ERRATA SHEET

DS26519

Revision A2 Errata

Figure 1

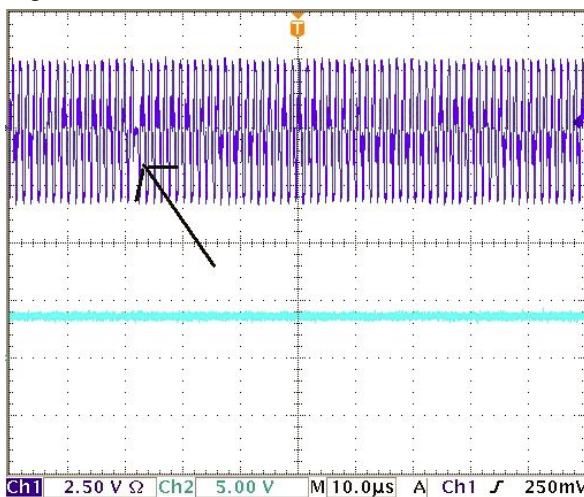
The TTIPn/TRINGn line drivers should be high impedance whenever TXENABLE is low. On rev A2 devices, the TTIPn/TRINGn line drivers are briefly enabled during power-up, even if TXENABLE is low. This may cause the inactive DS26519 in a Y-cable application to attenuate the transmit waveform of the active DS26519 and create a bit error, as seen in the figures below.

None.
